Appendix D Public Participation Documents

**Notification of Availability of Draft Environmental and Social Impact
Assessment Report for review and comment and Invitation to Public
Meetings**

BW KUDU LIMITED**Environmental and Social Impact Assessment for Proposed
Appraisal Well Drilling in Block 2814A (PPL 003), Orange Basin,
Off Southern Namibia****REGISTRATION & COMMENT FORM****12 February 2025**

No.	Comment Received	Response
	 <p>Figure 6-36: Spatial distribution of annual average effort (no. of trawls) recorded by the demersal trawl fishery in Namibia and South Africa in relation to Block 2814A. The 200 m depth contour is indicated in dark grey</p>

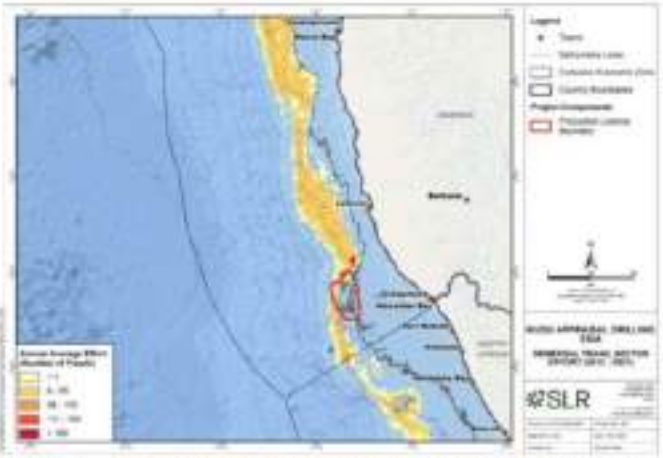
1.17.	<p>Fisheries</p> <p>Expansion of hydrocarbon exploration or exploitation infrastructure on the seafloor poses a physical risk to the fishing industry, especially those that use methods of fishing along the seafloor, such as demersal or bottom trawling.</p> <p>The potential expansion of hydrocarbon exploration or related infrastructure poses a risk to the fishing industry not just under worst-case-scenarios of spills or leakages, but also through the simple addition of physical</p>	<p>The Fisheries Impact Assessment considers both the project specific impacts on fishing, as well as the cumulative impacts (see Item 1.10). When assessing only the proposed activities by BW Kudu (this application), the various fishing grounds and spatial distribution of catch and effort (based on data provided by MFMR) are considered in relation to the estimated zones of impact (including exclusion, noise and drilling discharges), informed by the modelling studies and mandatory safety exclusion zones.</p> <p>When considering the potential impacts on the demersal trawl sector, which is specifically mentioned in this comment, the extent of the fishing grounds is considered in relation to all the current oil and</p>

No.	Comment Received	Response
	<p>infrastructure that can interact with fishing gear. This is particularly relevant in such a high-value fishing region that is supported by the unique oceanographic conditions that make southern African waters among the most productive in the world due to the Benguela Current and upwelling system. Furthermore, bottom (demersal) trawling is a common and significant component of the fishing industry in this region, which makes the likelihood of negative interactions between fishing gear and seafloor infrastructure (active or abandoned) much higher than in areas where demersal trawling is not common.</p> <p>According to the Marine Stewardship Council, "Fishing is the third largest sector of Namibia's economy, with hake making up the majority of the sector." Hake is a species caught specifically by the method of demersal trawling, and the map displayed in Figure 6-36 (below) of the ESIA shows demersal trawling takes place in the block proposed for this project. However, Annex I's fishery report attempts to minimize the scale of negative impact by describing the amount of demersal fishing that happens in this block as a small percentage of the nation's overall demersal trawl fishery production. This grossly underestimates the pressure the fishery will feel from the cumulative impacts of multiple blocks being explored for oil and it skews the impacts that may be felt by specific subgroups of the fishery's stakeholders given that the block in question contains almost all of demersal trawling grounds at that latitude in Namibian waters.</p>	<p>gas exploration and appraisal activities, as well as potential future production activities, in southern Namibia. However, it is important to acknowledge that not all current and proposed activities will have an impact of the demersal trawl sector, which typically operates between depths of 300-800 m. Currently oil and gas activities are being undertaken or proposed in the following blocks in southern Namibia, with only three overlapping with demersal trawl sector (as indicated):</p> <ul style="list-style-type: none"> • 2813A (Galp): Overlap. • 2814A (BW Kudu): Overlap. • 2912 (TEEPNA): No overlap. • 2913B (TEEPNA): No overlap. • 2913A (Shell): No overlap. • 2914B (Shell): No overlap. • 2813B (Harmattan / Chevron): No overlap. • 2914A (Rhino): Overlap. <p>BW Kudu is proposing to remove the wellheads of plugged and abandoned wells on completion of the appraisal activities. In this case, there would be no risk posed to the trawling sector at the end of appraisal drilling operations. If the wells are to be suspended, the intention is to leave the wellhead(s) on the seafloor if it is deemed safe to do so based on a risk assessment. In this case, it's important to note that the sector would not be excluded from the entire Block due to decommissioned infrastructure on the seafloor. The demersal trawl sector would trawl around or lift nets off the seabed to avoid the suspended wellheads (to avoid damage to their trawl gear).</p> <p>However, a key mitigation measure recommended in the Fisheries Impact Assessment is the employment of over-trawlable caps:</p> <p><i>"Any suspended well located in water depths >300 m, should be covered with an over-trawlable cap to reduce the risk of damage to demersal trawling gear and the wellhead".</i></p> <p>Additionally, the position of suspended wellheads would be charted by SANHO as a navigational hazard.</p> <p>SLR is of the opinion that the impact on fisheries has not been underestimated.</p>

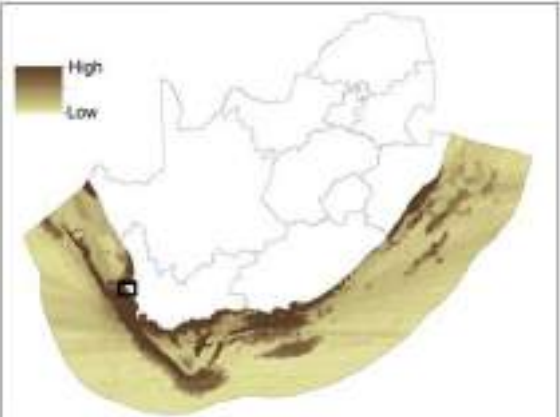
1.24.	<p>Furthermore, this section incorrectly claims there is no evidence of cumulative impacts from offshore oil wells in South African and Namibian waters:</p> <p>“Despite the number of wells drilled in the South African and Namibian offshore environment, there is no evidence of long-term negative change (cumulative impacts) to faunal population sizes or irreparable harm as a direct result of these exploration and appraisal activities.”</p> <p>A National Biodiversity Assessment conducted in South Africa in 2018 provides an analysis of cumulative impacts – the resulting figure below shows a significant portion of the western South African coast and shelf edge is already experiencing high levels of cumulative pressures and impacts. The study notes: “areas of high cumulative pressures translate</p>	<p>The extract pasted in the comment has been taken out of context. This paragraph relates specifically to well drilling and the impact cuttings discharge and sediment plume, and not all “cumulative pressures and impacts”.</p> <p>The Marine Ecology Impact Assessment (Section 5.3) notes that “the total cumulative area impacted by the installation and cuttings fall-out of approximately 35 wells in the Namibian EEZ (which has a total area of approximately 562 212 km²) is estimated at 16 km². In reality the total cumulative impacted area at any one time is considerably less, due to the natural dispersion and recovery of benthic communities in unconsolidated sediments over the short to medium (shallow waters) and long term (deeper waters)”.</p> <p>As noted in Item 1.23, interaction of the project with past and current activities and impacts, are captured in the baseline. In particular, when rating the sensitivity of the receptors, the status of the receiving environment (benthic ecosystem threat status, protection level, protected areas, etc.) or threat status of individual species is taken into consideration, which is based to some degree on past</p>

No.	Comment Received	Response
	<p>into areas of severe ecosystem degradation and poor ecosystem condition, particularly in the inner shelf and shelf edge..."</p> 	<p>and current actions and impacts (e.g., the IUCN conservation rating is determined based on criteria such as population size and rate of decline, area of geographic range / distribution, and degree of population and distribution fragmentation).</p>
